ABINGTON TOWNSHIP

BOARD OF COMMISSIONERS
REGULAR PUBLIC MEETING

A G E N D A
April 8, 2021
6:30 PM

Title
AQUA PENNSYLVANIA, INC.
NORTH HILLS WELL
PFAS TREATMENT SYSTEM
STORMWATER MANAGEMENT AND DRAINAGE PLAN

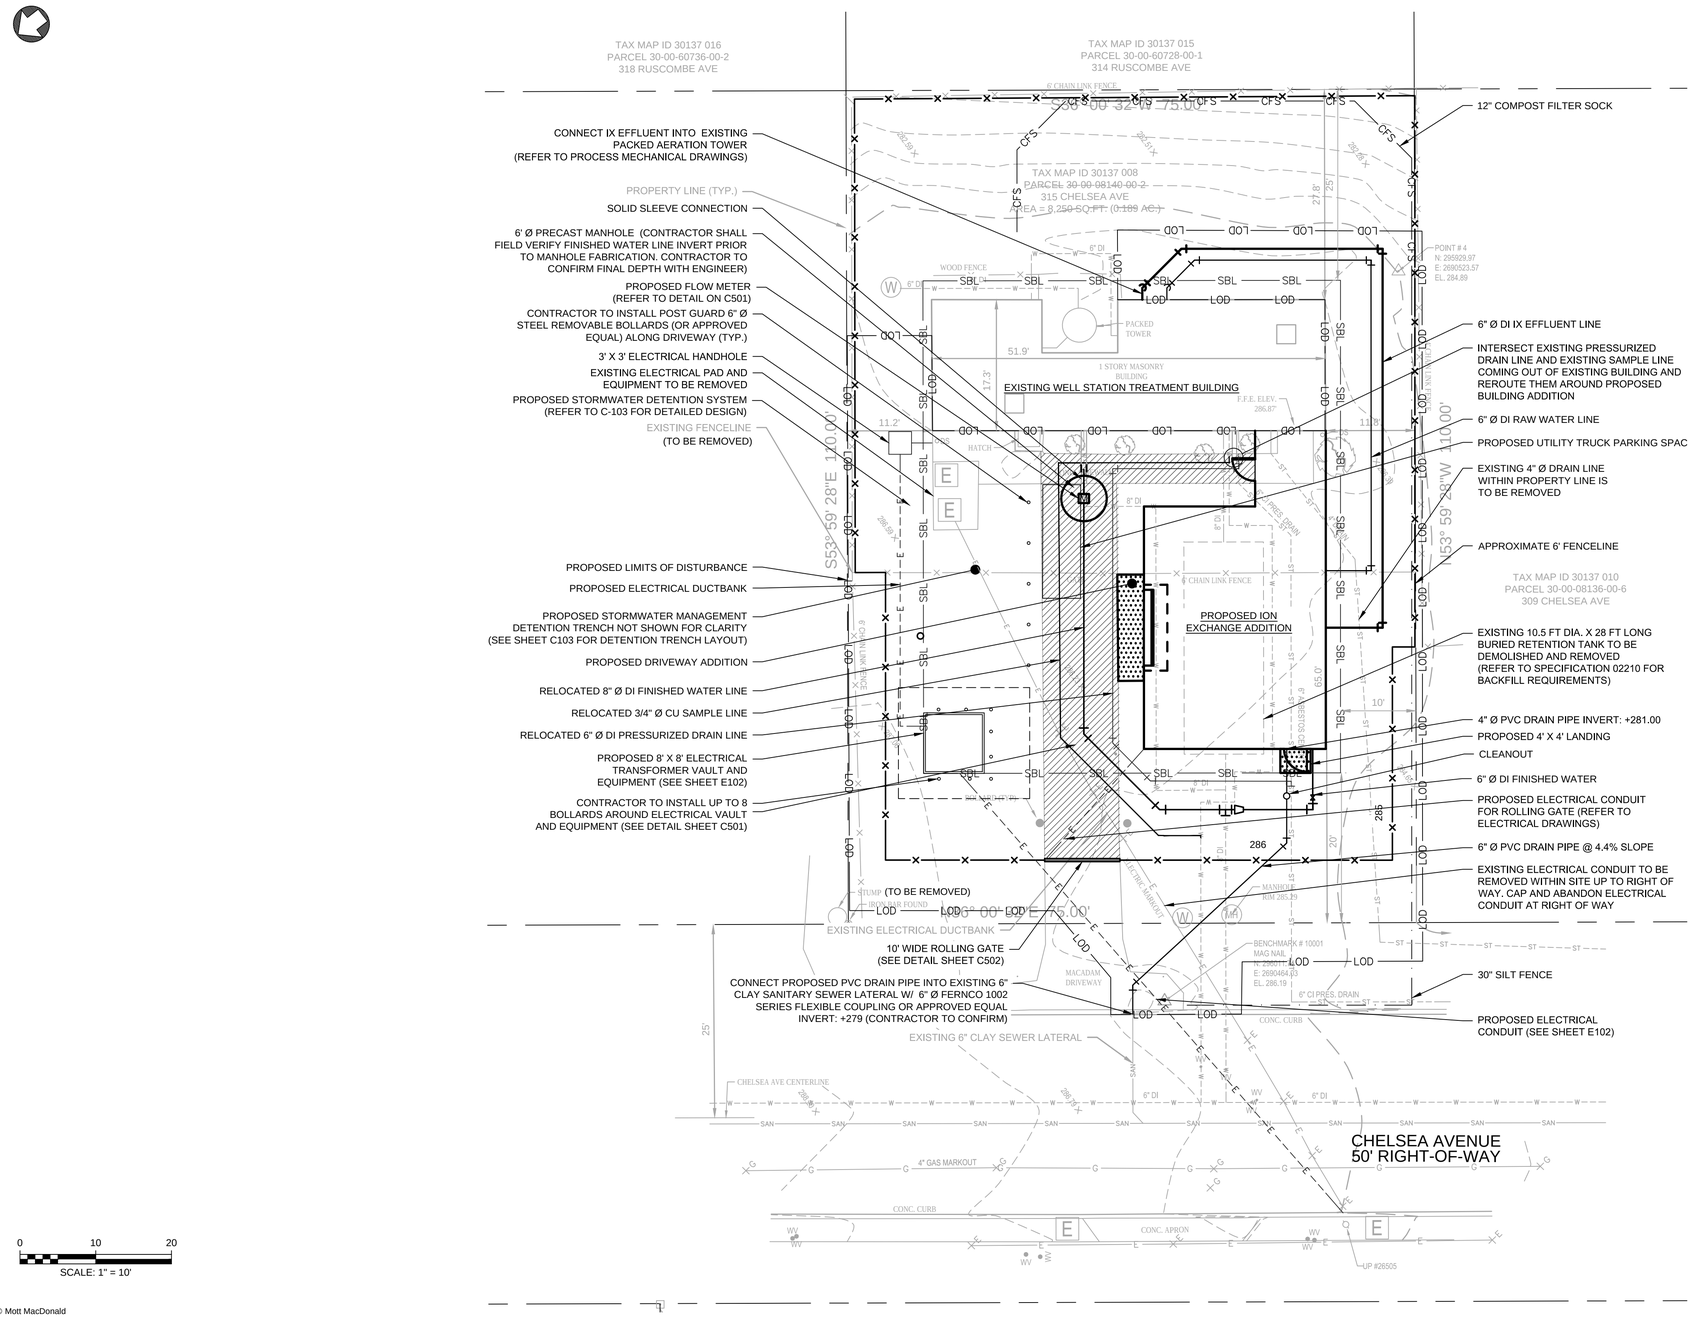
18. Per §142-302.B.(1)(m), the Stormwater Management Drainage Plan (Sheet C103) shall include the following signature block for the Municipality: *"(Municipal official or designee), on this date (date of signature), has reviewed and hereby certifies that the SWM site plan meets all design standards and criteria of the Municipal Ordinance No. (number assigned to the Ordinance)."*

22. Per §142-302.B.(2)(b)[25], a statement, signed by the applicant, acknowledging that any revision to the approved drainage plan must be approved by the Municipality, and that a revised erosion and sediment control plan must be submitted to the Municipality or Conservation District for approval. Please place this statement on the drainage plan (Sheet C103).

23. Per §142-302.B.(2)(b)[26], The following signature block for the Design Engineer shall be added to Stormwater Drainage Plan (Sheet C103):
    "I, (Design Engineer), on this date (date of signature), hereby certify that the drainage plan meets all requirements of the Department of Environmental Protection's (DEP's) regulations and this chapter."

MM Response (3/4/21): The specified signature block has been added to the Stormwater Management and Drainage Plan (Sheet C103).

MM Response (3/4/21): The specified statement, to be signed during the recording process, has been added to the Stormwater Management and Drainage Plan (Sheet C103).

MM Response (3/4/21): The specified statement, to be signed during the recording process, has been added to the Stormwater Management and Drainage Plan (Sheet C103).
